## **2022 GROUP B PROPOSED CHANGES TO THE I-CODES ROCHESTER COMMITTEE ACTION HEARINGS**

2021-2022 Code Development Cycle, Group B (2022) Proposed Changes to the 2021 *International Codes*

# FS1-22

**FIGURE 1410.3(1) SINGLE-SPAN VINYL OR ALUMINUM SOFFIT PANEL SUPPORT**

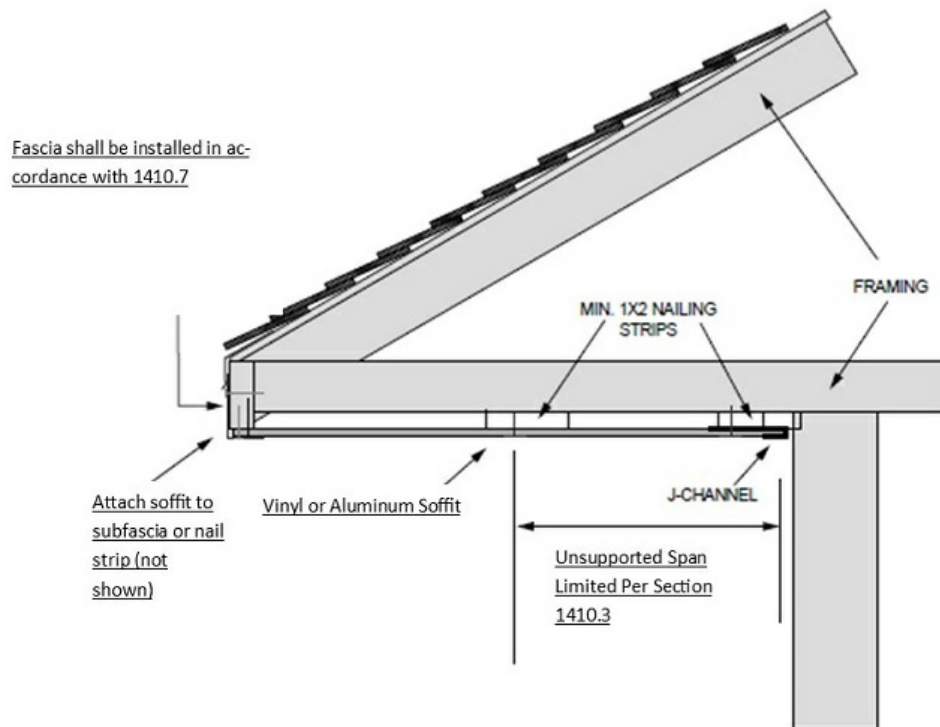
**1410.3 Vinyl and aluminum soffit panels.** *Vinyl and aluminum soffit panels shall comply with Section 1410.2 and shall be installed using fasteners specified by the manufacturer and shall be fastened at both ends to a supporting component such as a nailing strip, fascia or subfascia component in accordance with Figure 1410.3.1(1). Where the unsupported span of soffit panels is greater than 12 inches (406 mm) where the design wind pressure is greater than 30 psf or greater than 16 inches where the wind pressure is 30 psf or less, intermediate nailing strips shall be provided in accordance with Figure 1410.3.1(2). Vinyl and aluminum soffit panels shall be installed in accordance with the manufacturer's installation instructions. Fasteners shall be aluminum, galvanized, stainless steel or rust preventative coated nails or staples or other approved corrosion-resistant fasteners. Nails shall be T-head, modified round head, or round head with smooth or deformed shanks. Staples, where permitted, shall have a minimum crown width of 7/16 inch (11.1 mm) outside diameter and be manufactured of minimum 16-gage wire.*

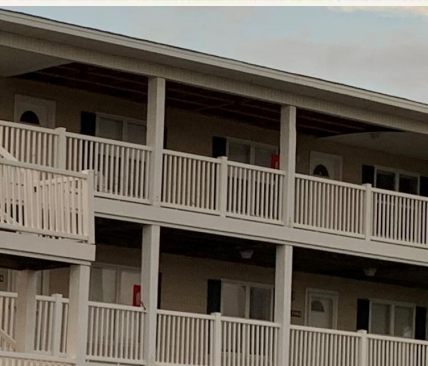
Observations of non-residential soffit failure that led to water infiltration include the University of Florida Institute of Food and Agricultural Sciences Bay County Extension Building (Panama City, FL) shown below (MAT Report Figure 5-16). Several vinyl soffit panels were also blown away from the wood frame roof overhang, thereby exposing the attic space to entrance of wind-driven rain. Interior water intrusion was exacerbated by loss of roof top equipment and leakage at hip closures which led to collapse of the gypsum ceiling.
